TDG Ref: 12834.001
27 February 2015

North Kumutoto Precinct Project
Response to WCC Request for Further Information

Council's Request dated 5 February 2015 seeks further information and clarification on a number of urban design, traffic and related matters.

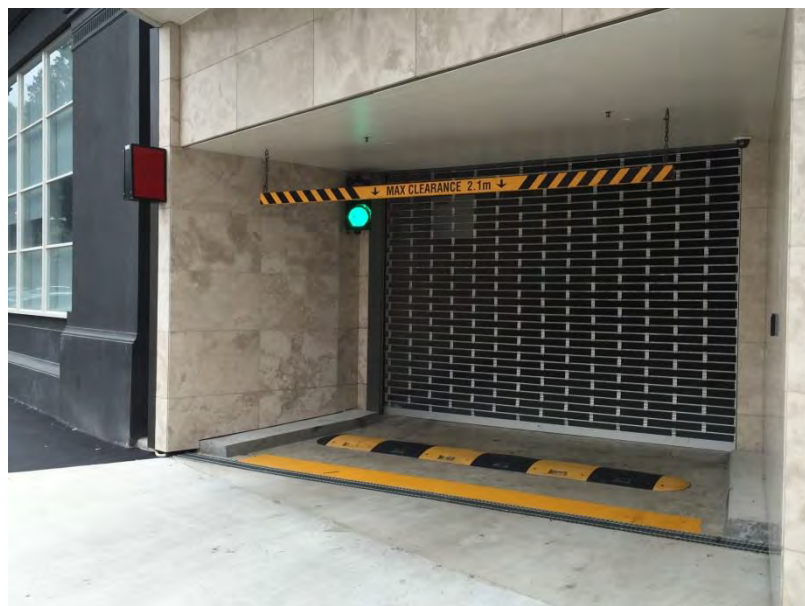
- 17.** *Please explain what measures will be implemented to ensure that vehicles exiting the parking ramp will not compromise public safety. These could include measures to warn pedestrians along the building edge of exiting vehicles (via an audible and/or visual system), as well as signal controls for users of the one-way ramp for entry and exit.*

Note: Council's Traffic Advisor has suggested that speed bumps should be installed near the exit of the commercial building to ensure that this is a low-speed environment.

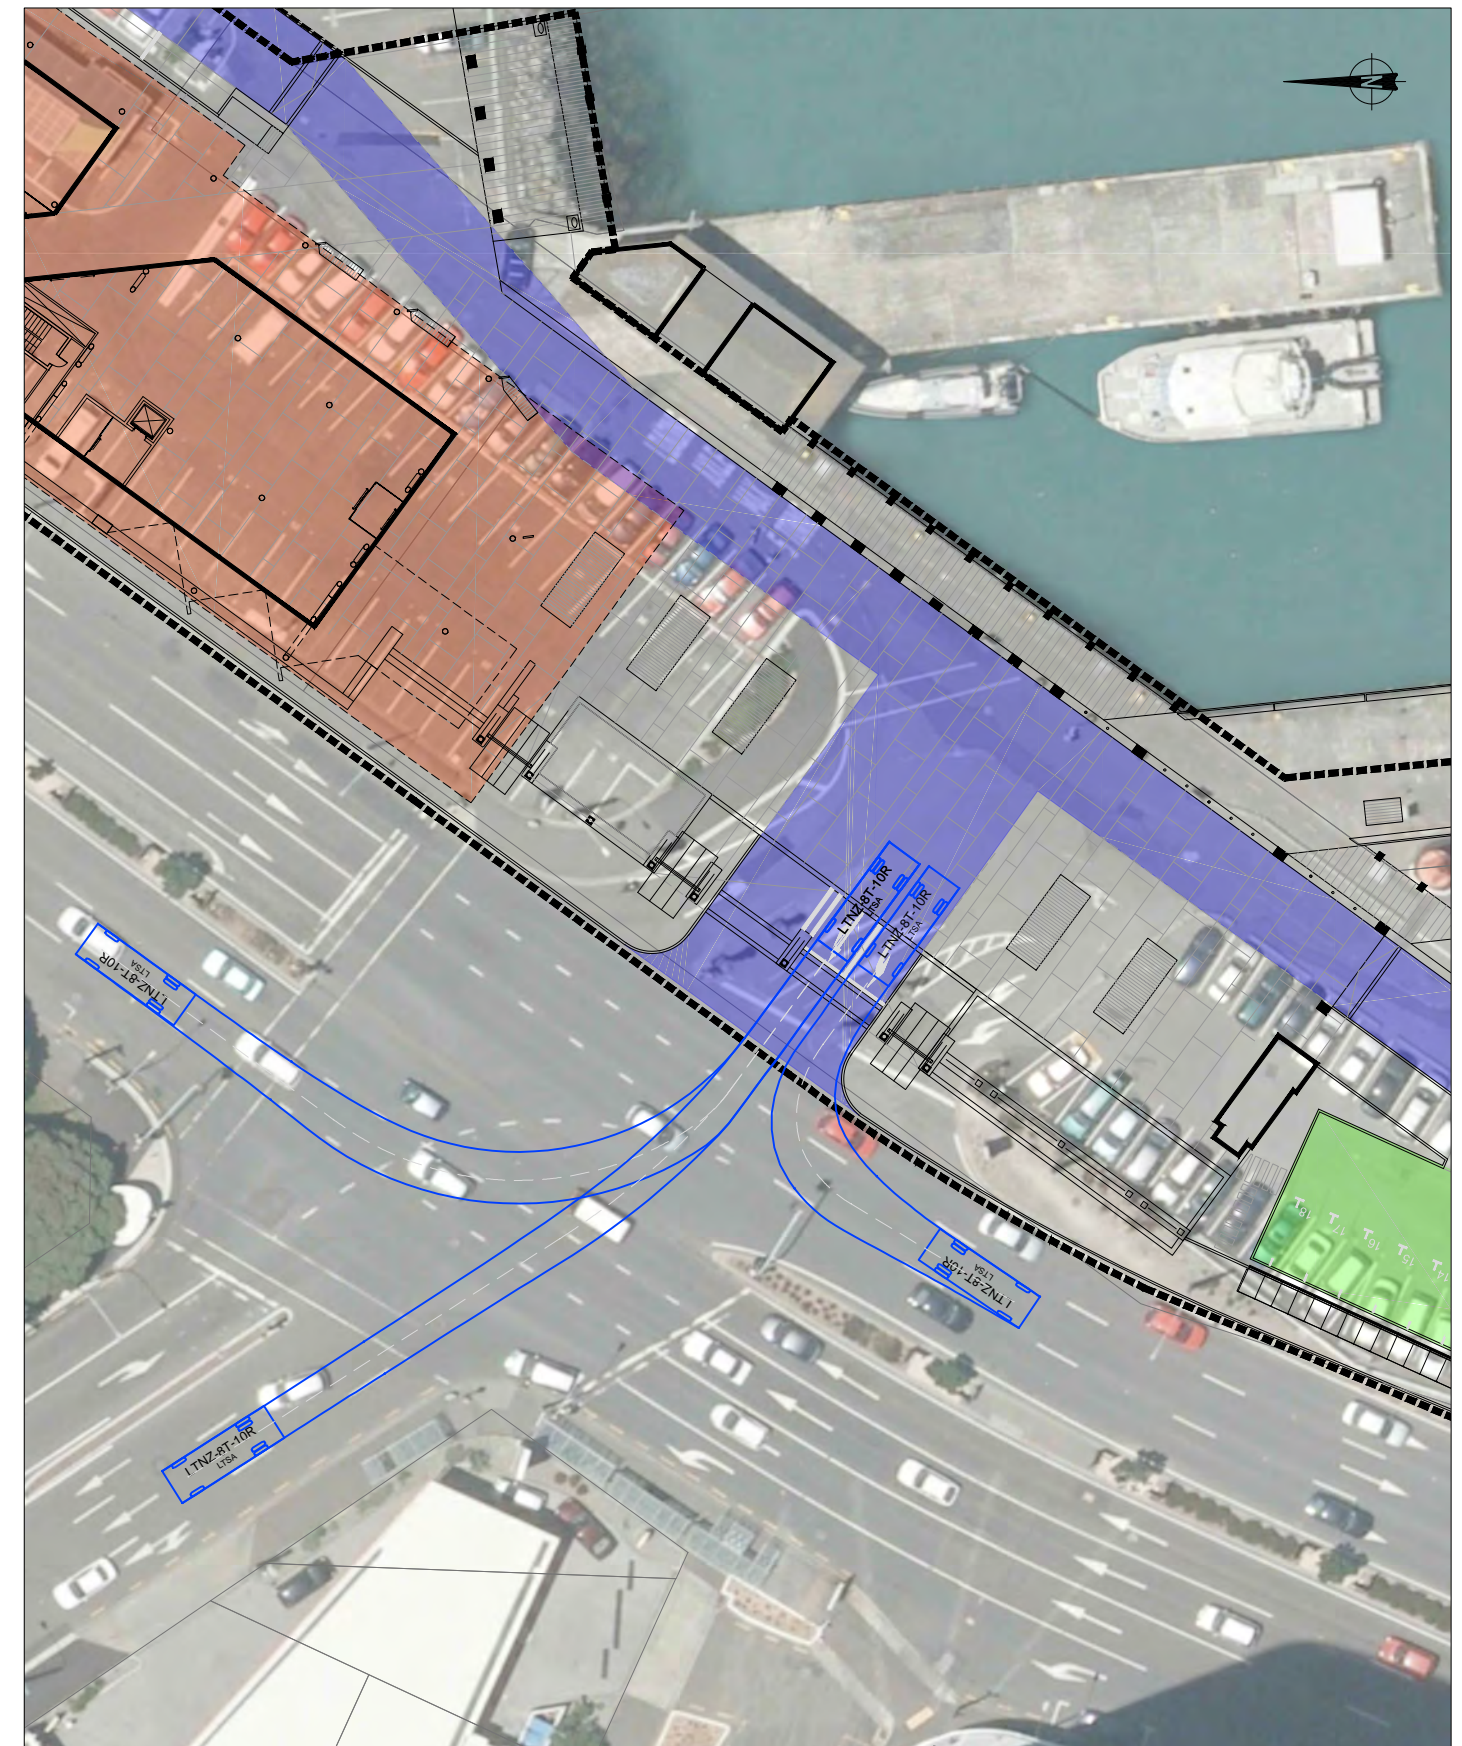
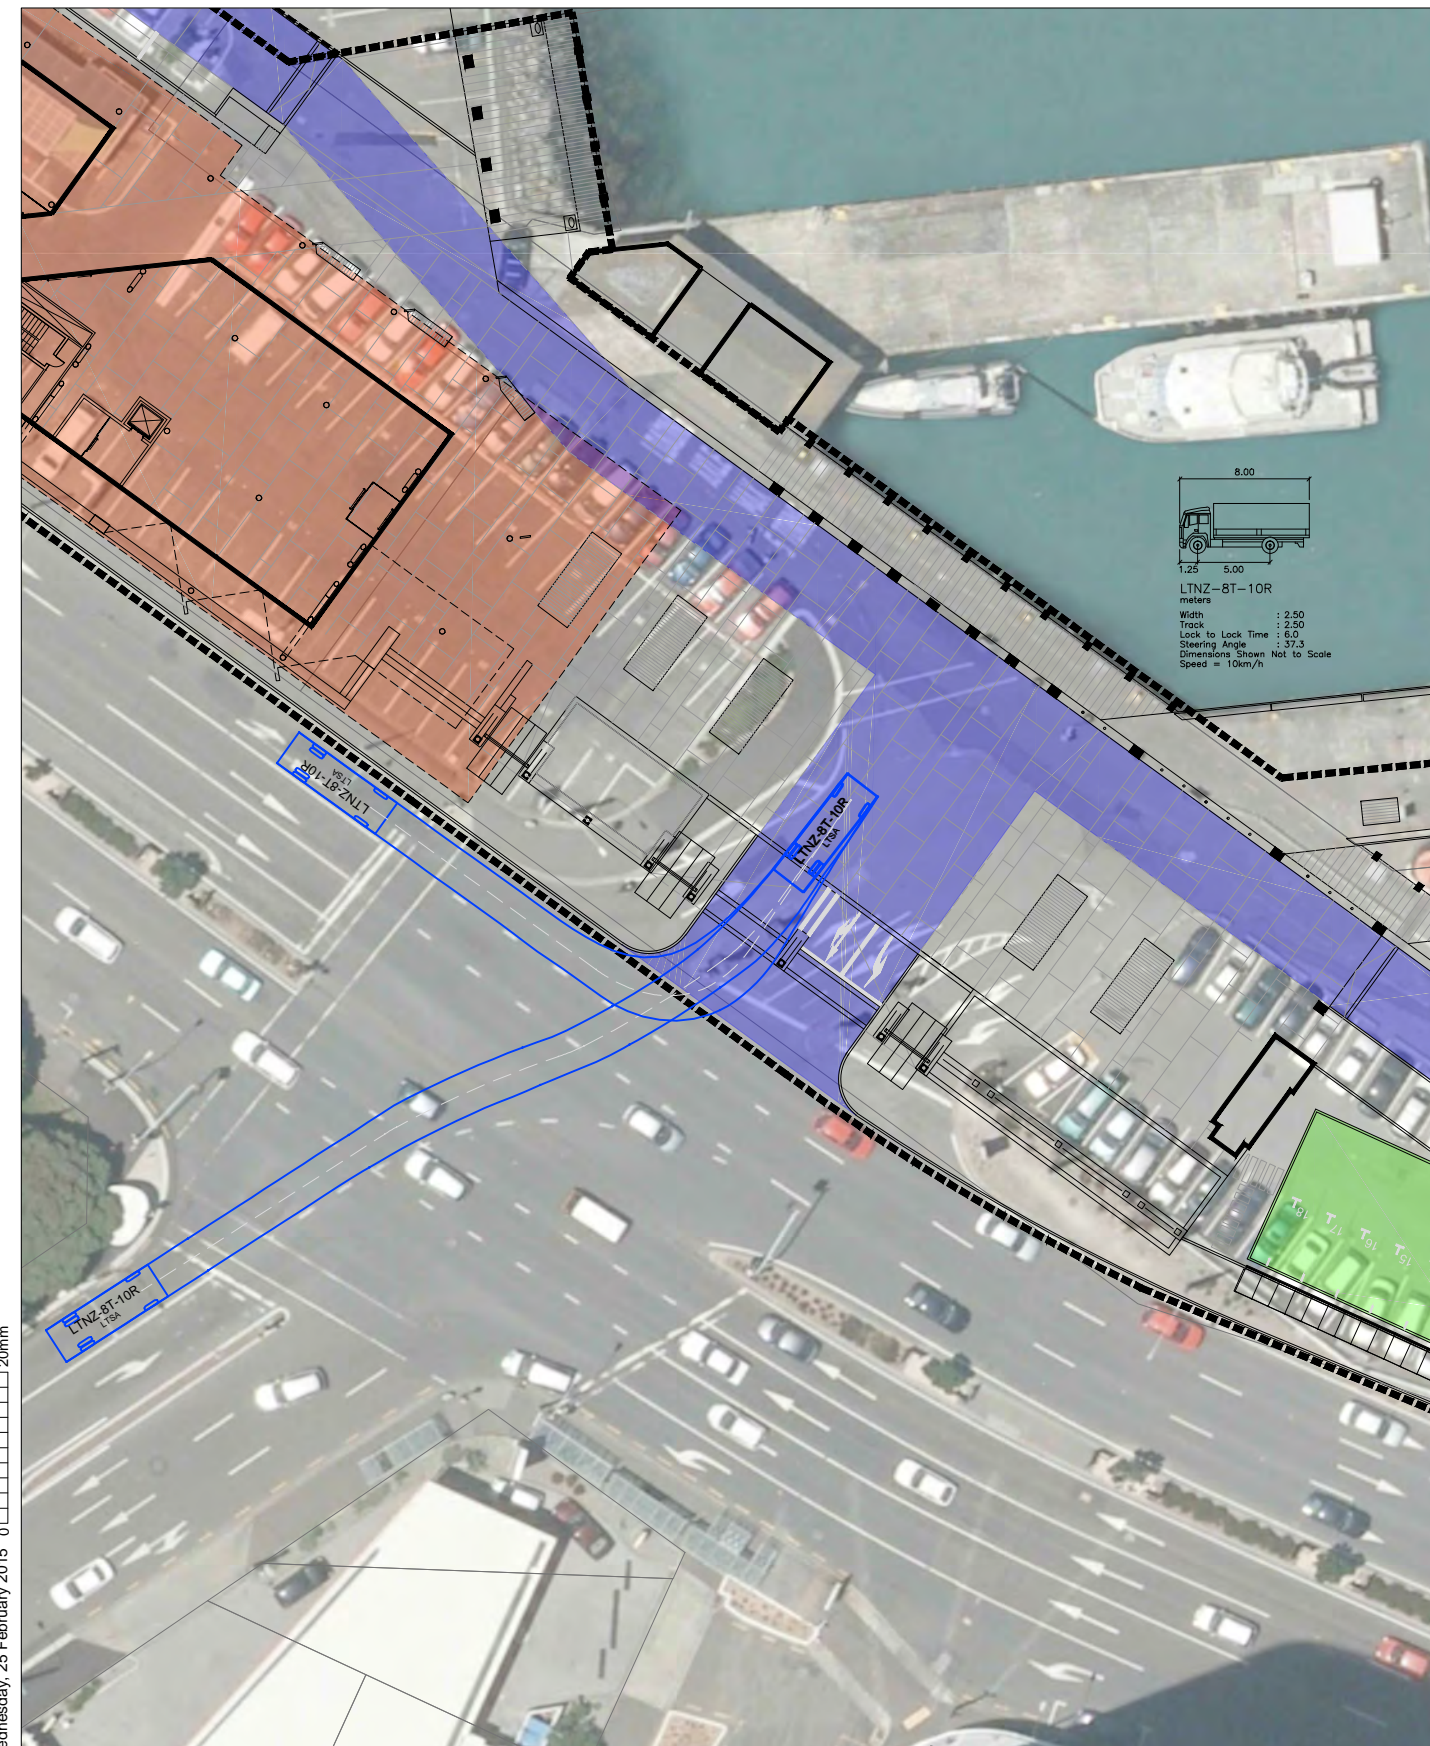
- 10** *Please provide full details of the intersections (and approaches) and the pedestrian crossing facilities across Customhouse Quay, north of Whitmore Street. These details should include lane widths, dimensions and turning paths and other relevant details which assist in their operation.*

Appendix A includes a scaled plan with dimensions (refer Drawing number 1.045 prepared by Isthmus).

Kumutoto Precinct: Site 10 and Open Space Development
Intersection Tracking for Medium Rigid Truck

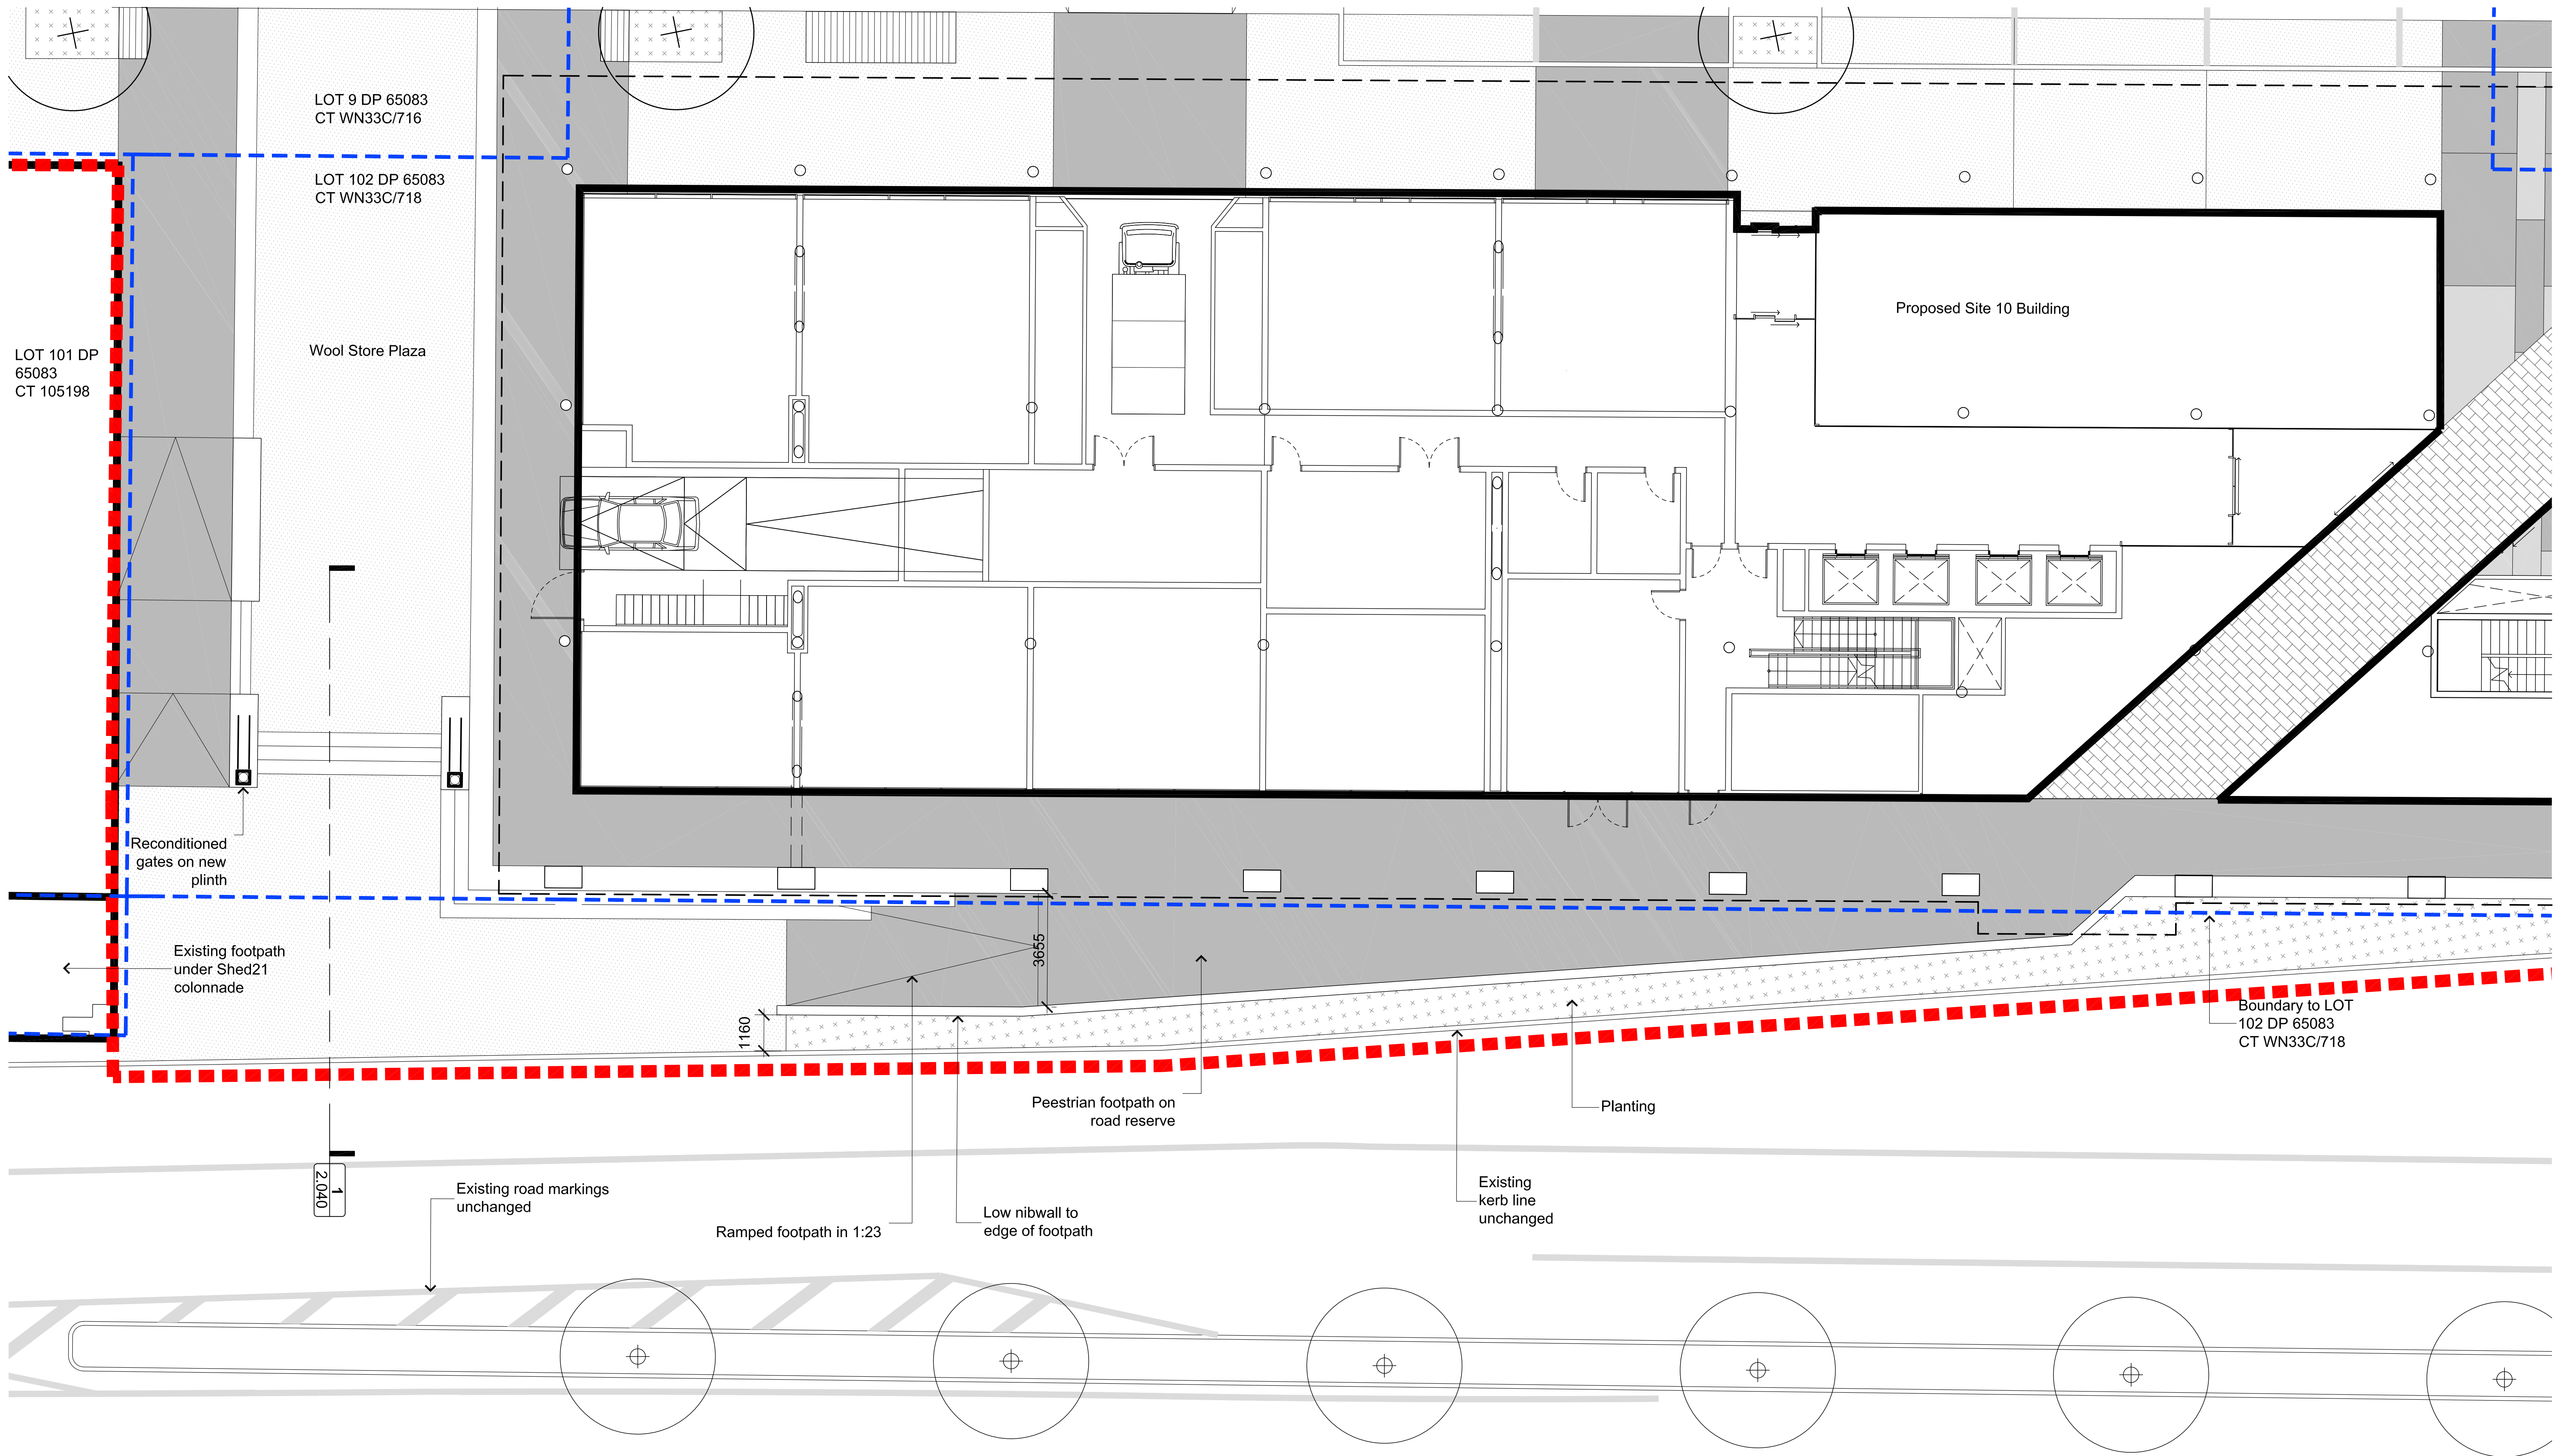
- 18.** *Please provide tracking paths for larger service vehicles (semi-trailer and a large rigid truck) turning into and out of the intersection with the narrowing of the entry and exit at Customhouse Quay.*

Appendix A also includes a separate plan illustrating the tracking paths of a standard 8m truck, as defined by the District Plan, turning to and from Customhouse Quay (refer Figure 8 prepared by TDG).

As confirmed at the 10 February meeting, the area of North Kumutoto and its activities and buildings do not attract articulated trucks. Rather a standard 8m truck, as defined by the District Plan, is the appropriate design vehicle.

Such a truck is suitably representative of a standard 7.7m Type 2 Medium Pumper fire appliance and a 8.0m Type 3 Heavy Pumper fire appliance.

The tracking paths for an 8m standard truck turning into and out of the intersection were included earlier in response to Item 10.
